**Date:** March 12, 2020  
**To:** Interested Person  
**From:** Benjamin Nielsen, Land Use Services  
503-823-7812 / [Benjamin.Nielsen@portlandoregon.gov](mailto:Benjamin.Nielsen@portlandoregon.gov)

**NOTICE OF A TYPE II DECISION ON A PROPOSAL IN YOUR NEIGHBORHOOD**

**CASE FILE NUMBER: LU 19-247650 DZ – DESIGN REVISIONS TO BLOCK 216**

PLAN DIAGRAM | CATENARY LIGHTS

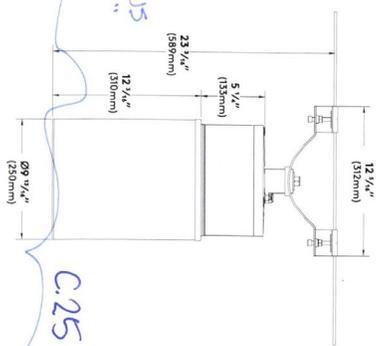
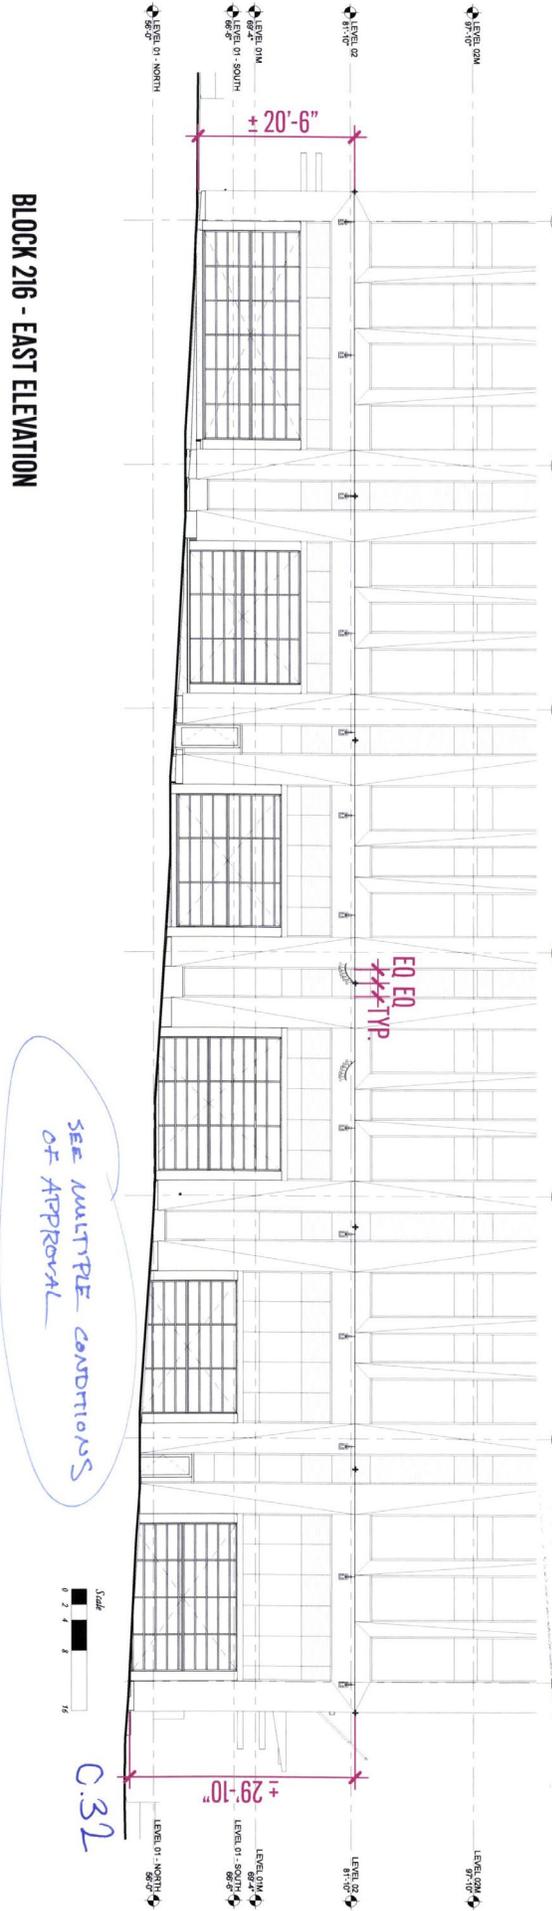
- The proposed new catenary lighting over SW 9<sup>th</sup> Ave will visually and physically enhance the pedestrian environment and will help to create a virtual “ceiling” over the pedestrianized streetscape of this street segment. This lighting and the additional enclosure it helps to create will add to the vibrancy already created by the previously-approved active storefronts facing SW 9<sup>th</sup> Ave. Two different options for organizing the catenary lighting were proposed as part of this review: one aligned the catenary light fixtures such that they were aligned in four columns running parallel to the street. The second option staggers the catenary light fixtures to help break up the linearity of the fixtures. This second option provides a greater sense of urban enclosure over the street, and therefore greater vibrancy, and will be approved with a condition of approval requiring this pattern rather than the linear pattern.

- Drawings on the lighting plan for the catenary lights, Exhibit C.25, indicate that the proposed fixtures nearest to the buildings on either side of the street will have shields “at the house side”. This would have the undesirable effect of creating dark spots on the fixtures, many of which will be located near the middle of the street (on the catenary lines with only three fixtures). The pedestrianized streetscape on SW 9<sup>th</sup> Ave, a link in the proposed Green Loop, would be better enhanced without the proposed shields. A condition of approval stating that no shielding can be used will be included to reinforce this finding.

- C. No field changes allowed.
- D. If the proposed city Ordinance to allow the installation of catenary light fixtures (aka: string lights) over SW 9th Ave is not adopted by City Council, and/or if the necessary encroachment permit to extend catenary light fixtures over SW 9th Ave is not approved by PBOT, then another Design Review will be required prior to the issuance of the main building permit to consider new/different streetscape elements for SW 9th Ave. Additionally, reconsideration of the Modification to zoning code standard 33.510.215.B.5. would also be required as part of such a future Design Review, since Condition of Approval J from LU 18-210124 DZM AD would not otherwise be met.

*SEE CONDITIONS OF APPROVAL "D" & "G"*
